Input Data

Plan Amendment

Figure 1: Added lanes between version 8.3 and 8.3.1.

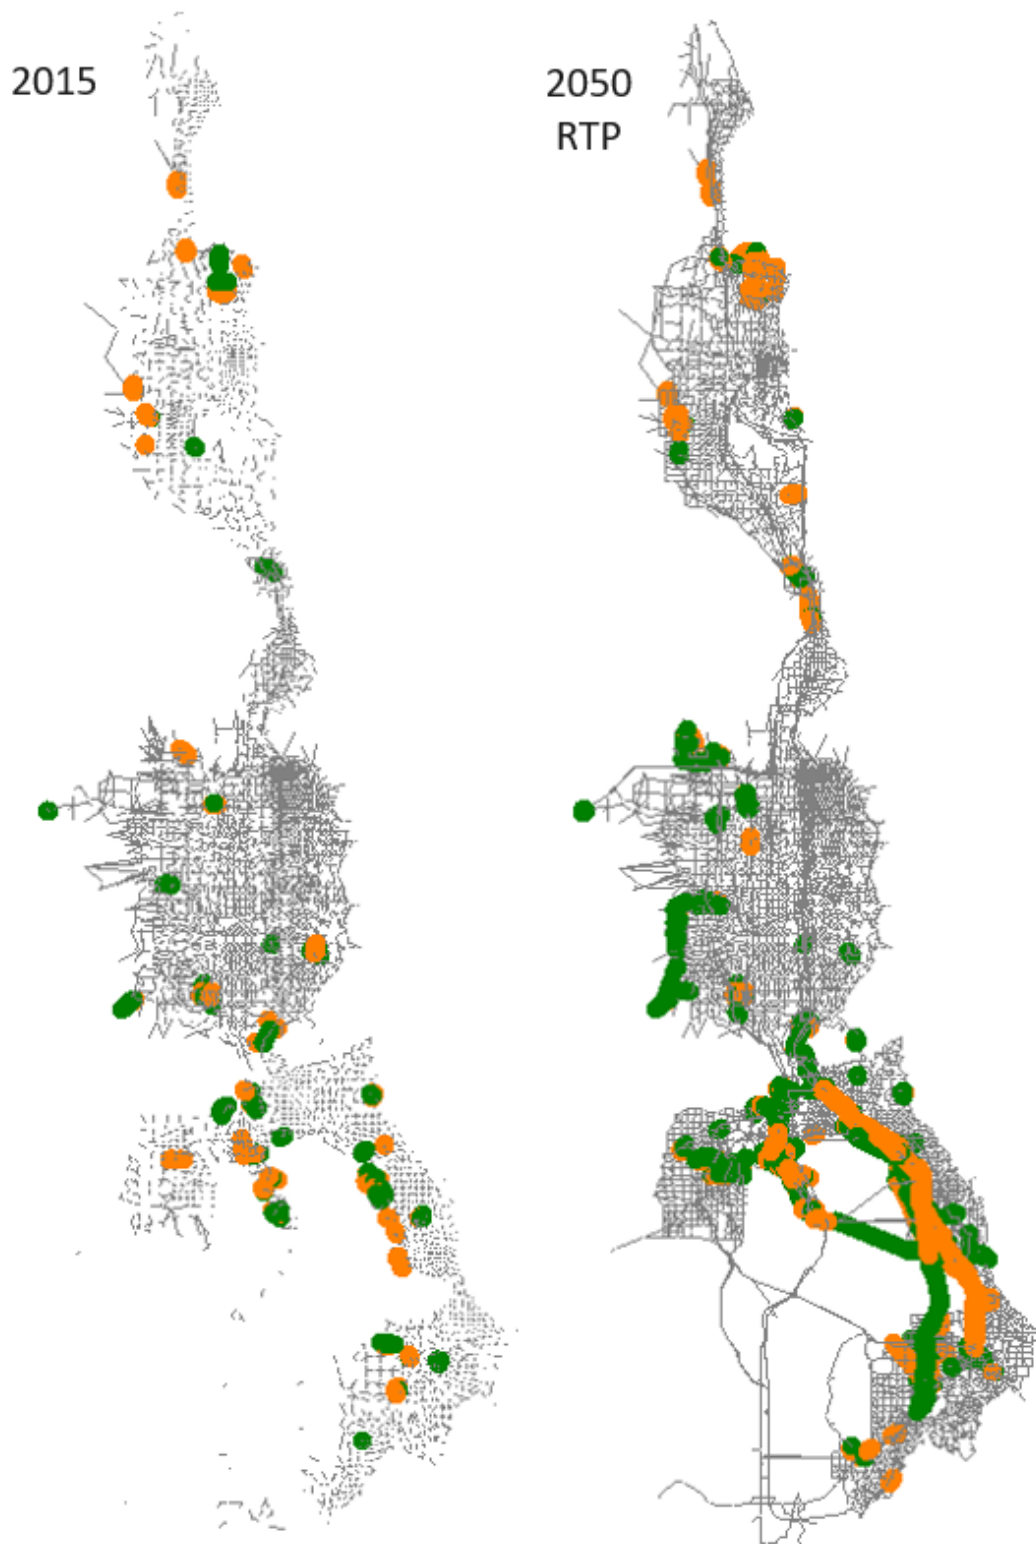
The highway network was updated in the MAG and WFRC areas to reflect the first round of Regional Transportation Plan (RTP) amendments. Additional edits were made in the MAG area to conform with more recent project clarification. The changes to the input highway network are significant, particularly in Utah County, and would most likely affect the travel model's output. Projects in and around areas of high change may want to do sensitivity tests to better understand the impact that these input network changes may have had on project-level decisions. Figure [1](#) shows where lanes were added (green) or were taken away (orange) between versions 8.3 and 8.3.1 highway networks.

Figure 1: SR 201 connection externals.

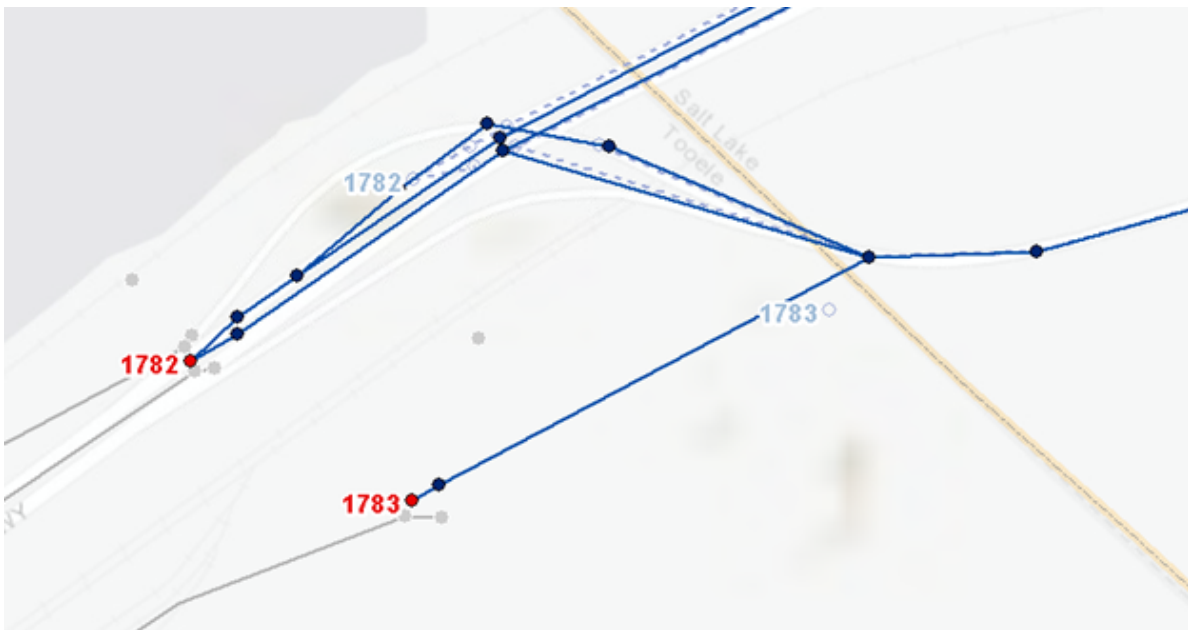
The highway network was modified at the Salt Lake, Tooele County boundary to provide an independent connection to SR 201 at external 1783. (Note external 1783 existed in the version 8.3 network as a place holder and was not connected to the network in that version.) Externals 1782 and 1783 were moved to improve the connection between the Wasatch Front and USTM travel models. The connecting highway links were also modified to accommodate this change.

External 1783 is connected to the highway network via a high-speed divided highway (FT=14) beginning in the 2030 fiscally-constrained plan year. In this year, external volume forecasts also begin for external 1783. Prior to 2030, external 1783 is unconnected to the scenario network and the external volume is zero.

Figure 2: Average weekday traffic volumes for externals 1782 and 1783.

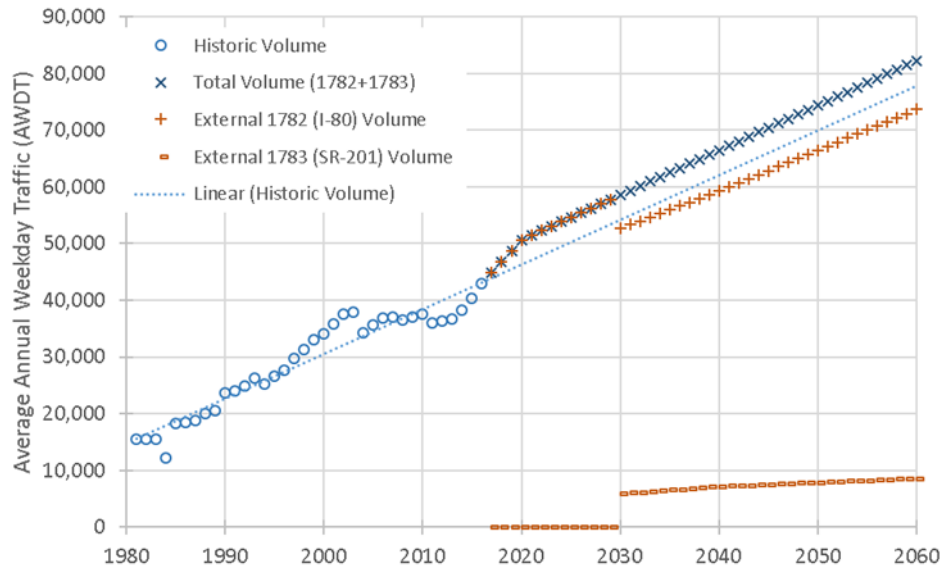
The external volume source file and model input files, '_Source_ExternalTAZ_HistoricalAADT - 2020-04-30.xlsx' and 'external_year_vol.csv' found in '1_Inputs\5_External Ext_Vol_Control', were updated to reflect the changes in externals 1782 and 1783. The forecast annual average daily traffic (AADT) for external 1782 was carried forward from version 8.3. The version

8.3 volume was then divided between the two externals based on information from the Utah Statewide Travel Model (USTM) and professional judgement. The average weekday, single-unit and combo-unit factors for external 1782 were brought up to date with the most current information from the master segment shapefile in the model input folder:

- Average Weekday Factor = 1.057 (was 0.980)
- Single-unit Truck Factor = 7.6% (13%)
- Combo-unit Truck Factor = 9.8% (was 10%)

While the forecast AADT is identical to version 8.3, the change in weekday factor increased the input volume into the Wasatch Front model space by roughly 6%. The relative share of these trips also changed with significantly fewer medium trucks and more passenger cars. The share of heavy trucks stayed about the same. The weekday and truck factors for external 1783 were set to be equal to external 1782.
